Item 3.**Development Application: 61-63 Macleay Street, Potts Point - D/2022/1363**

File No.: D/2022/1363

Proposal Summary: The application seeks development consent for the adaptive reuse of, and alterations and additions to the existing building fronting Macleay Street and Challis Avenue. The primary land use sought is hotel accommodation, with a ground level food and drink premises.

Figure 42: Three dimensional axonometric drawing extract depicting the 15 metre height plane and the proposed non-compliant building elements, facing north-west

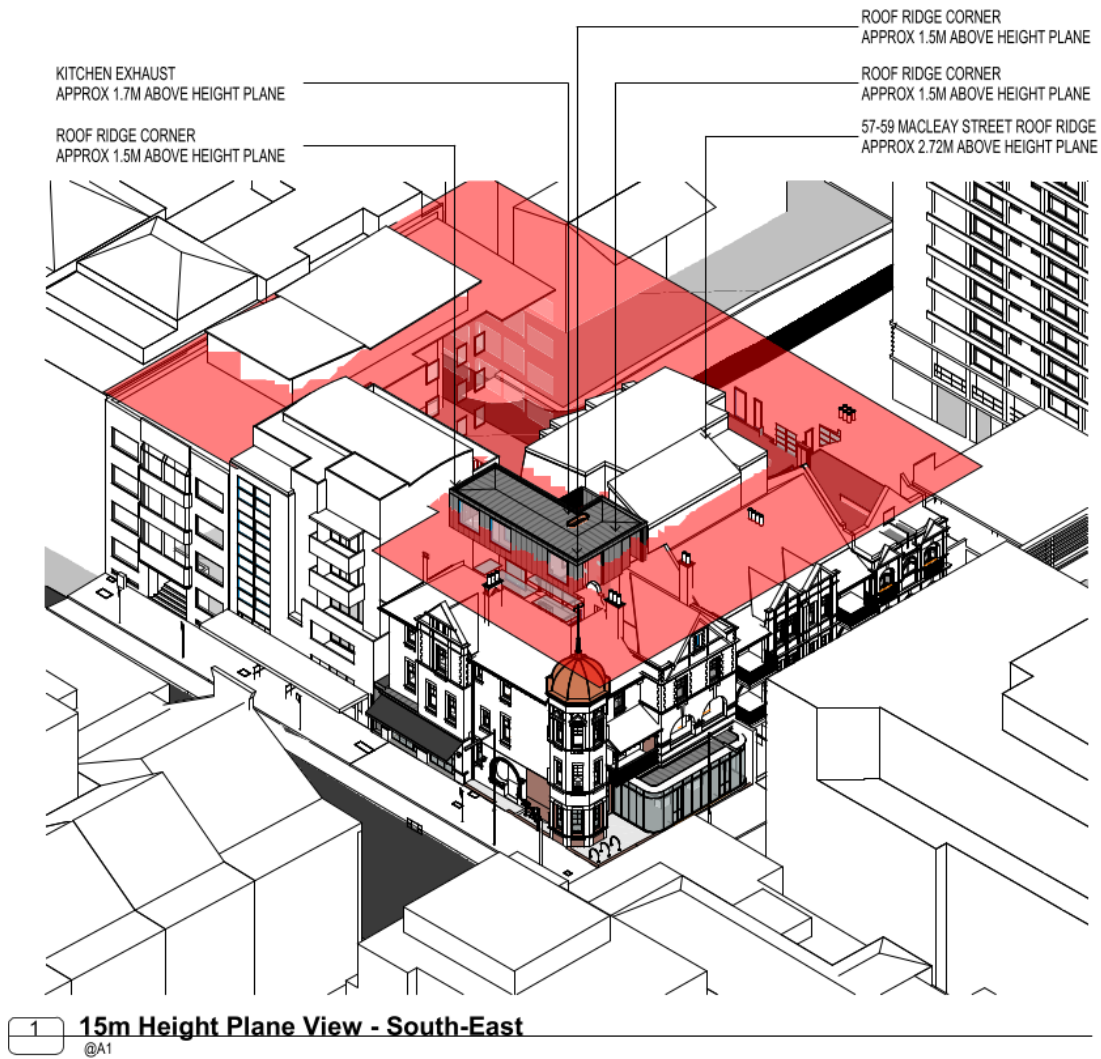
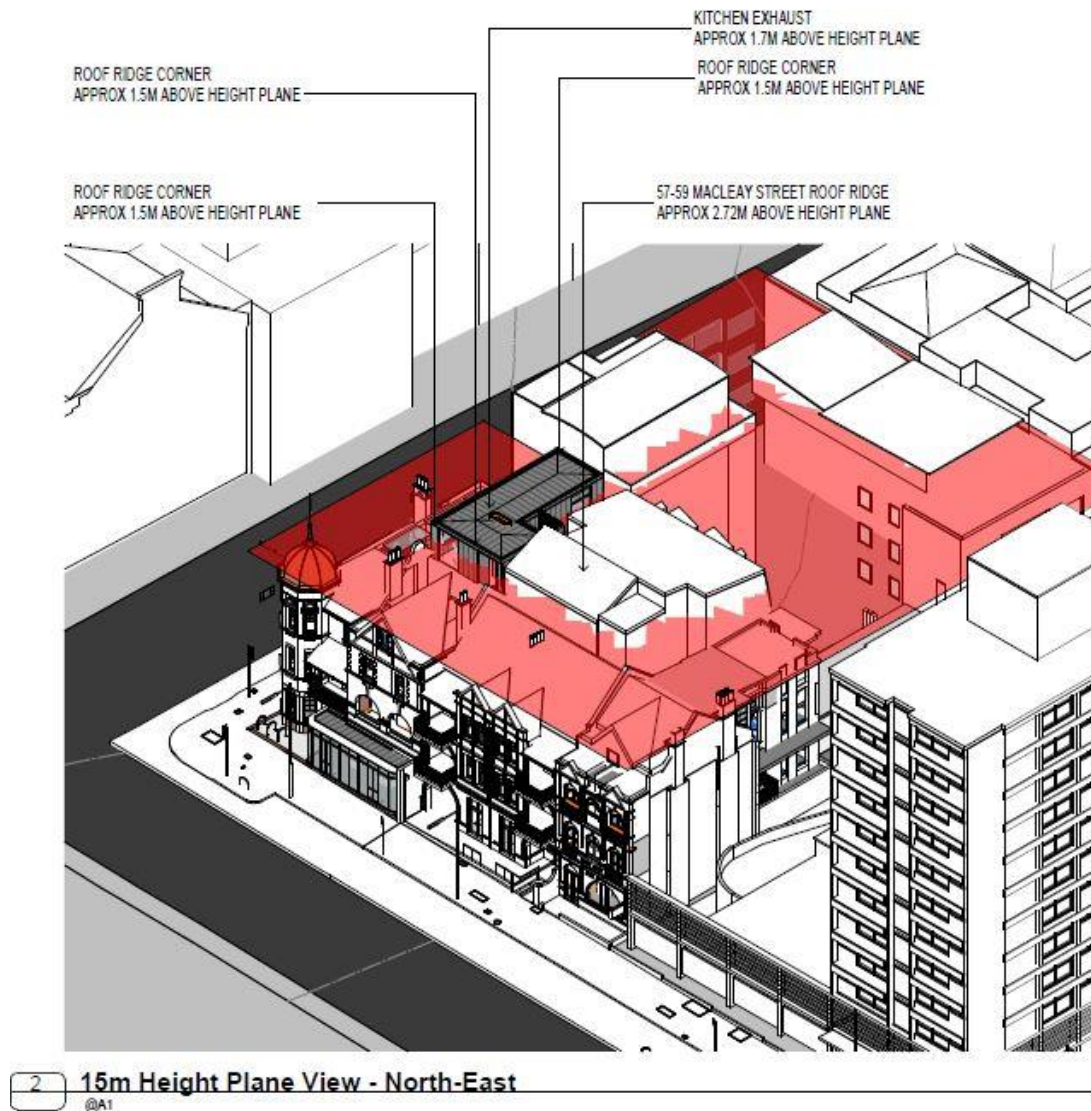
- (vi) Despite an identified non-compliance with the provision at 4.2.1.1(1) of the Sydney DCP 2012, the proposed five storey building achieves an appropriate height transition relative to surrounding contemporary and heritage listed buildings (as shown in the figures provided below) which vary in height from three to nine storeys.

- (vii) Notwithstanding previous development approvals involving non-compliances with height development standards, the contemporary aspect of the proposal remains consistent with the scale of neighbouring buildings to the west when viewed from neighbouring properties and the streetscape.

- (b) That there are sufficient environmental planning grounds to justify contravening the standard in the following manner:
- (i) The proposal satisfies the objectives of the MU1 Mixed Use zone and the objectives of the Height of Buildings standard.
 - (ii) The reduced mass and scale of the amended proposal, which is the result of a decrease in the overall maximum building height and reconfiguration of the rooftop addition, ensures views over the site to the Sydney CBD skyline and to the Sydney Harbour Bridge are not adversely affected in a significant manner.
 - (iii) The proposal maintains the significance of the heritage item on the site and other items within its vicinity. The proposed works have been substantially amended to have careful regard to the fabric, setting, and view corridors of the heritage item itself and nearby items.

Figure 53: Three dimensional drawing extract of the location of 404/14 Macleay St (top left), unit plan drawing extract (bottom left), view photograph (top right) and modelled view of the proposal outlined in blue and shaded green (bottom right)

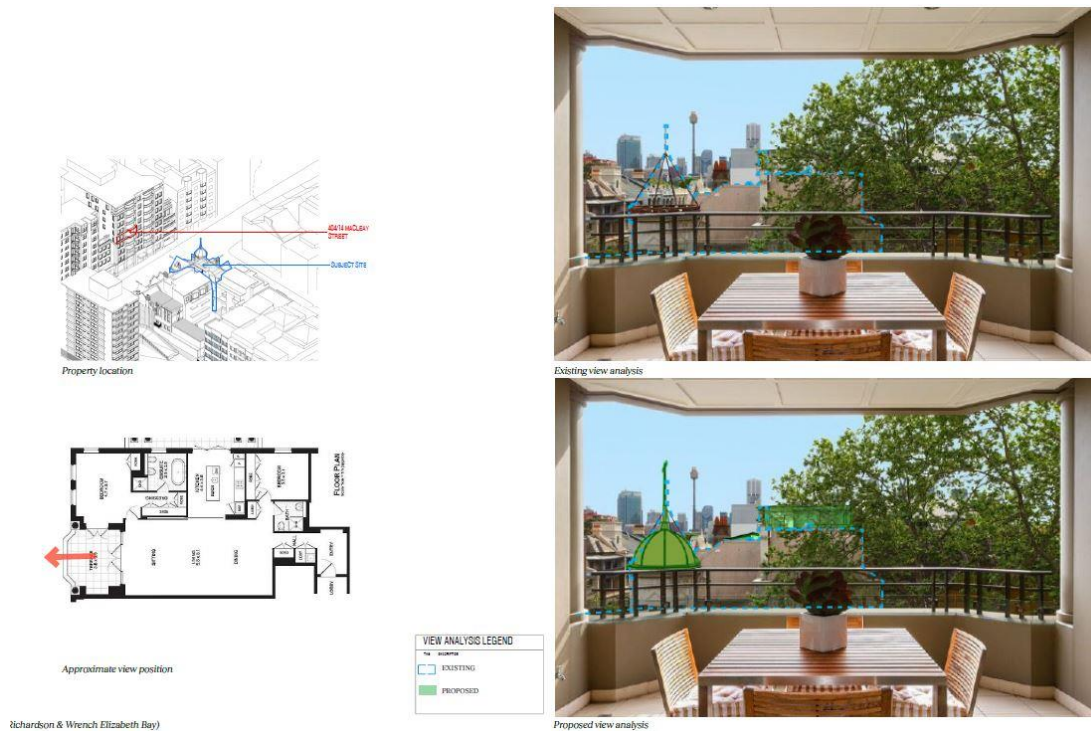
The amendments made to the proposal on 13 November 2023 provide a flat roof, a secondary setback from the ridgelines of the existing building which have minimised view impacts to a very small portion of the existing view, and maintained the clear majority of the views of the Sydney Central Business District from the property. The impact can be assessed as being minor in scope, as depicted in the figure provided below.

In the above context, the view impacts of the proposal are reasonable in this instance.

Figure 54: Three dimensional drawing extract of the location of 501/14 Macleay St (top left), unit plan drawing extract (bottom left), view photograph (top right) and modelled view of the proposal outlined in blue and shaded green (bottom right)

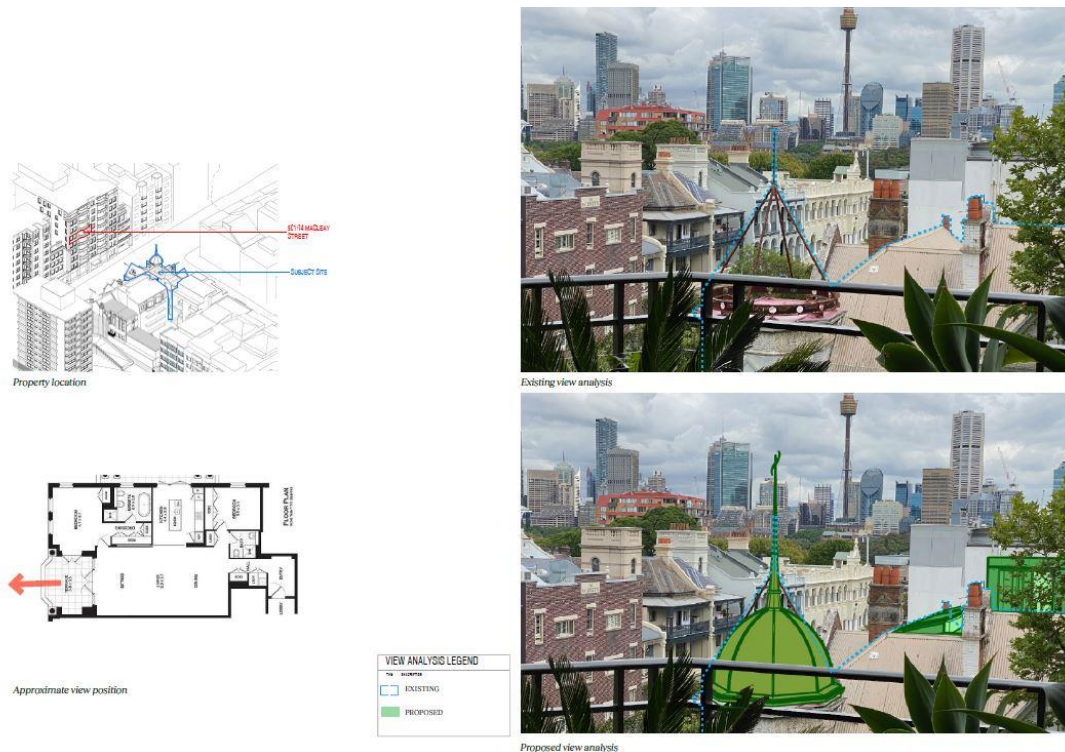
The work to restore the original cupola and spire is an important heritage outcome, and view impacts will be limited to a very small portion of the existing view, maintaining most of the views of the Sydney Central Business District from the property. The impact can be assessed as being negligible in scope, as depicted in the figure provided below.

In the above context, the view impacts of the proposal are reasonable in this instance.

Figure 55: Three dimensional drawing extract of the location of 503/14 Macleay St (top left), unit plan drawing extract (bottom left), view photograph (top right) and modelled view of the proposal outlined in blue and shaded green (bottom right)

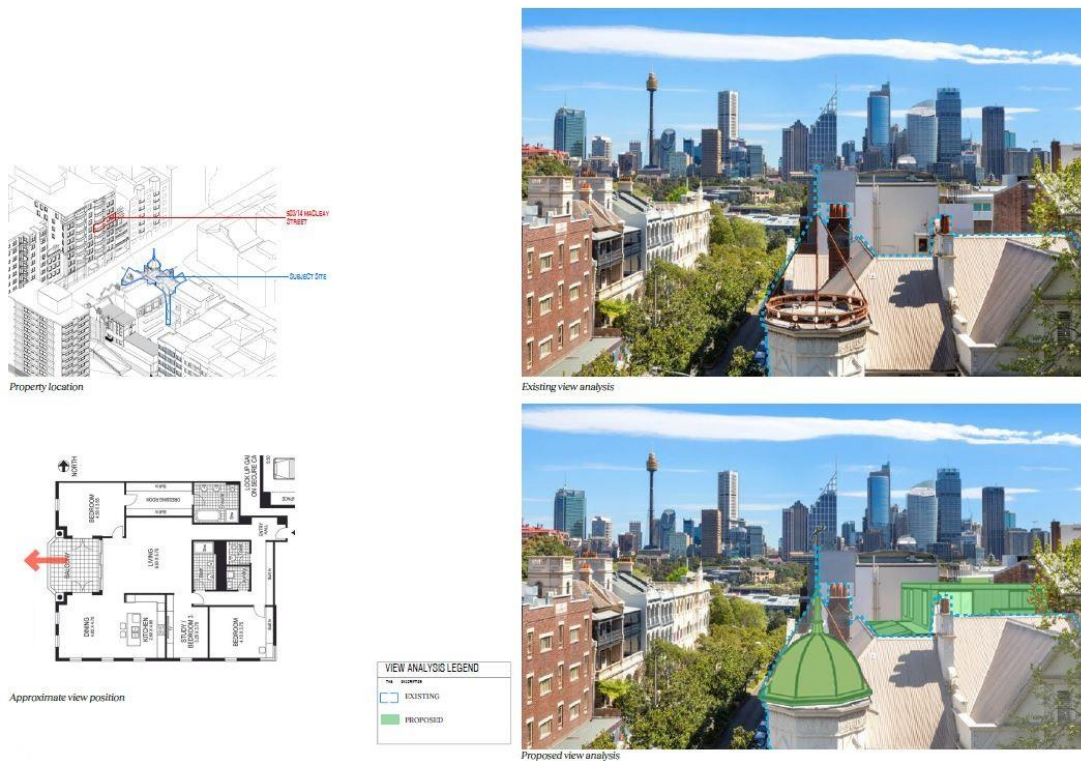
The work to restore the original cupola and spire is an important heritage outcome, and view impacts will be limited to a very small portion of the existing view, maintaining most of the views of the Sydney Central Business District from the property. The impact can be assessed as being negligible in scope, as depicted in the figure provided below.

In the above context, the view impacts of the proposal are reasonable in this instance.
